## TARGETED TRAFFIC RESPONSE LETTER

**Vantage**Yatala<sup>®</sup>

10 February 2025

**RESPONSE TO INFORMATION REQUEST (COM/2024/367)  
PROPOSED WAREHOUSE DEVELOPMENT  
LOT 204 VANTAGE ESTATE, YATALA**

**ATTACHMENT B - SURVEYED CAR PARKING DEMANDS AT VARIOUS WAREHOUSE DEVELOPMENTS**

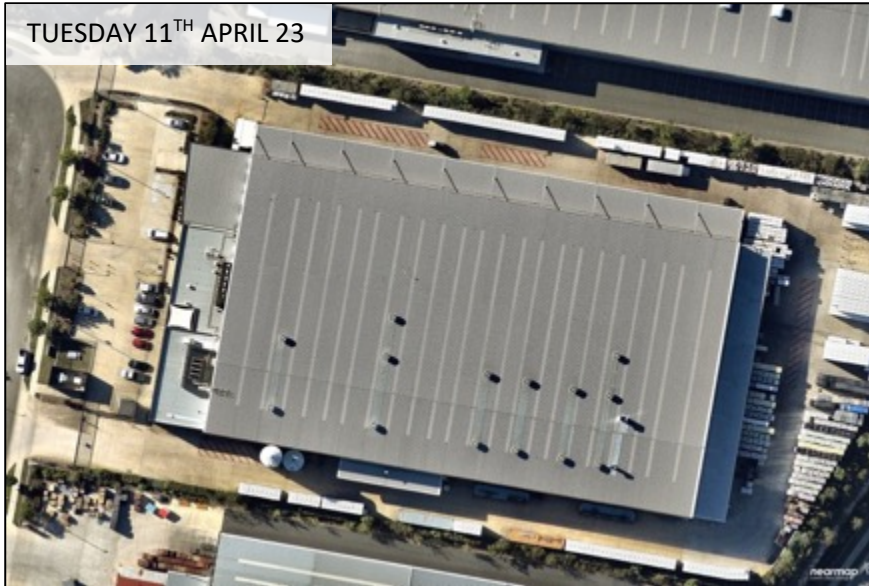
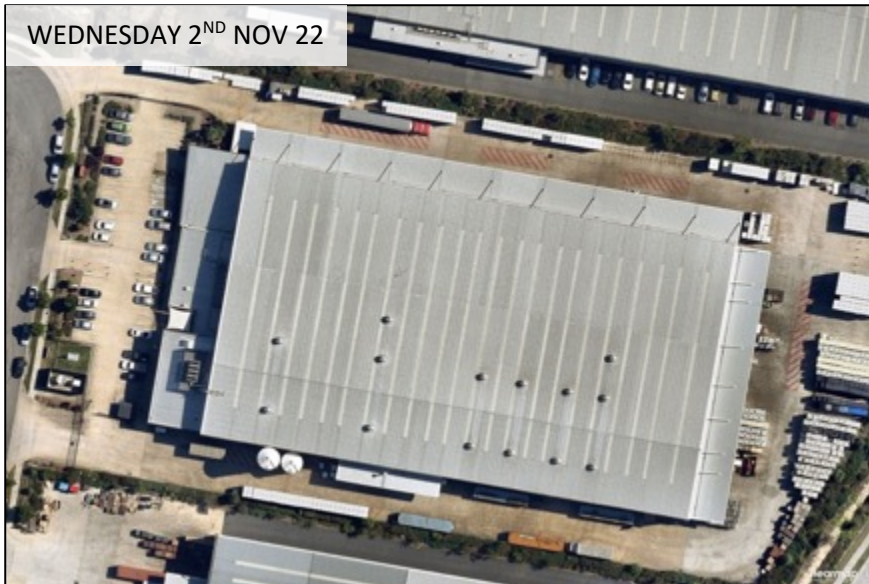
To comply with AS8.1.1, the proposed development requires 215 off-street car parking spaces. The proposal represents a significant parking shortfall, with only 100 car parking spaces proposed. The information provided in the Transport Impact Assessment does not provide sufficient justification to meet PC8.

Given that the end users and specific operations for the proposed development are unknown, the applicant is requested to demonstrate compliance with the prescribed parking rate. Alternatively, suitable and sufficient justification shall be provided to demonstrate that the expected parking demand will be fully accommodated on-site, in accordance with PC8 noting the above identified noncompliance with the Performance Criteria.

As depicted in Attachment A, a review of car parking utilisation has been carried out using Nearmap aerial imagery. As shown, the surveyed sites indicate low car parking utilisation, with car parking rates as low as 1 space per 600m<sup>2</sup> GFA. For the above reasons, the proposed provision of 100 car parking spaces will adequately service the proposed building without causing an overflow of parking demand into the public street system.

The results of the review are summarised in Table 4.1, with the car parking relationships detailed in Table 4.2.

As shown in Table 4.2, the surveyed sites indicate low car parking utilisation, with car parking rates as low as 0.17 spaces per 100m<sup>2</sup> GFA. RTE has been involved in many large warehouse unit developments and find that the rates shown below are typical of user requirements.

| <b>ATTACHMENT B -</b> | <b>FIRE TRUCK SWEPT PATH</b>                                         |

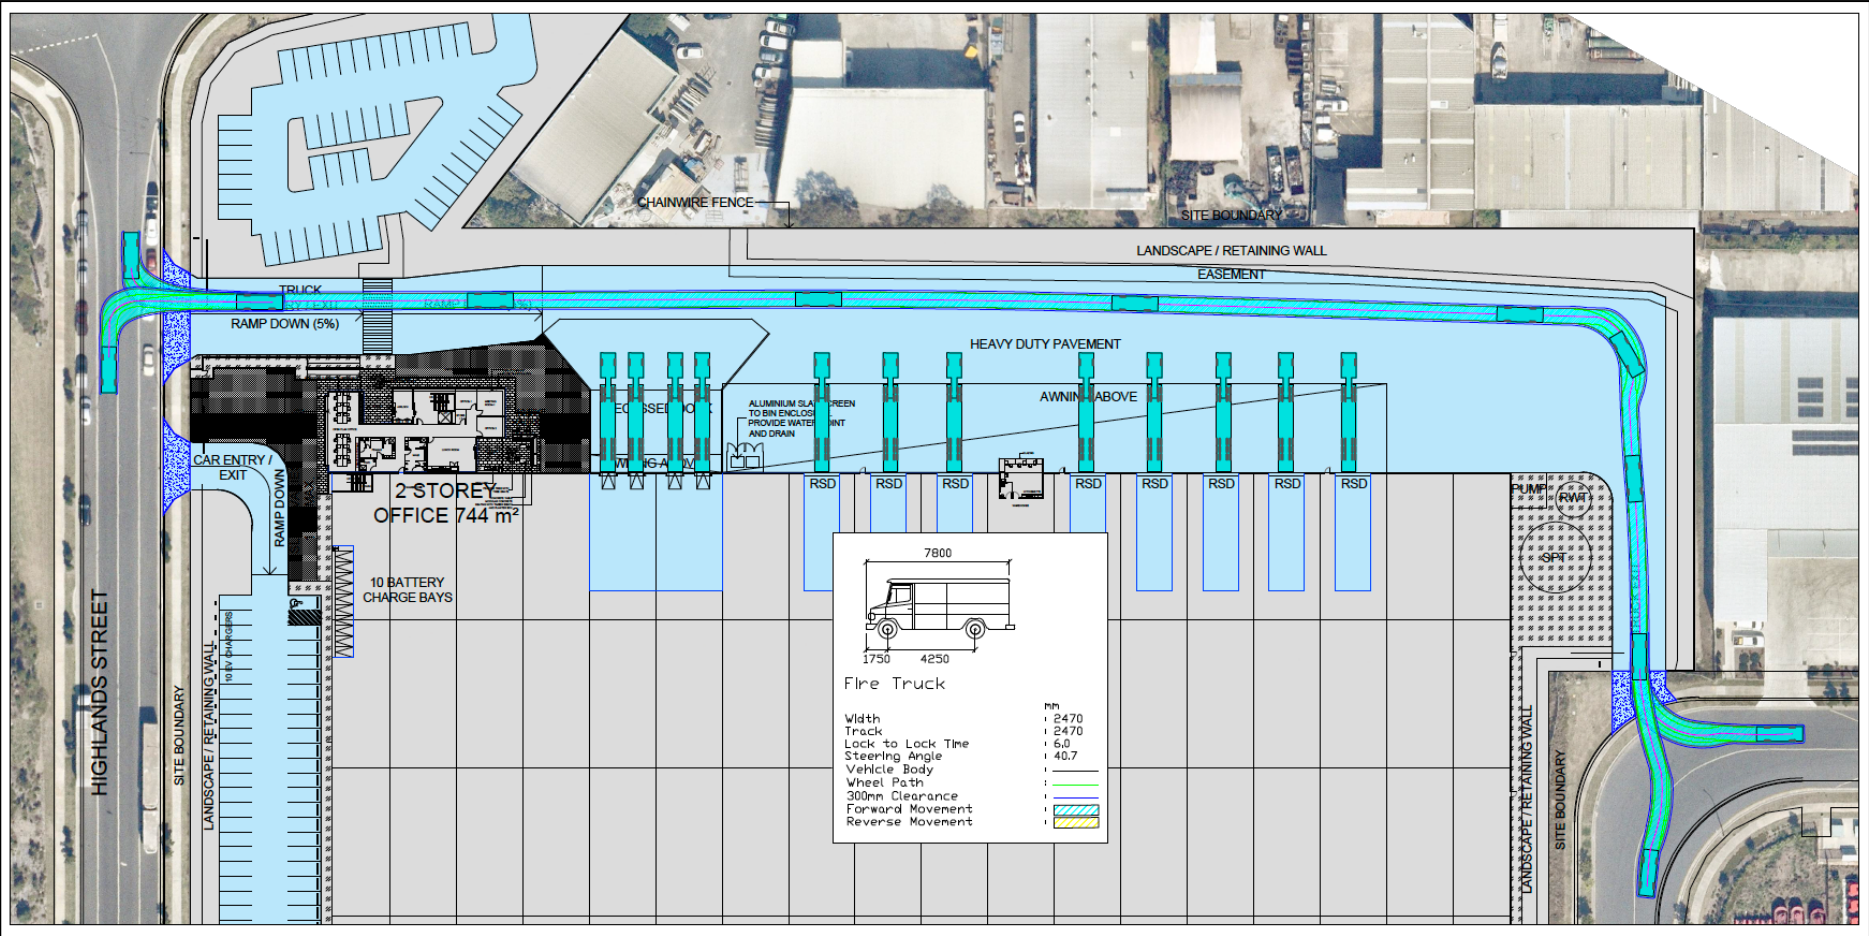
Submit a swept path to demonstrate that a fire truck is able to circulate from Lot 204, to the proposed easement in Lot 205 (and through Lot 205), with all movements achieved in a continuous, forward motion.

As shown in Attachment B, a swept path analysis has been carried out and demonstrates that a fire truck can circulate from Lot 204 to the proposed easement in Lot 205, and through Lot 205, with all movements achieved in a continuous forward motion.
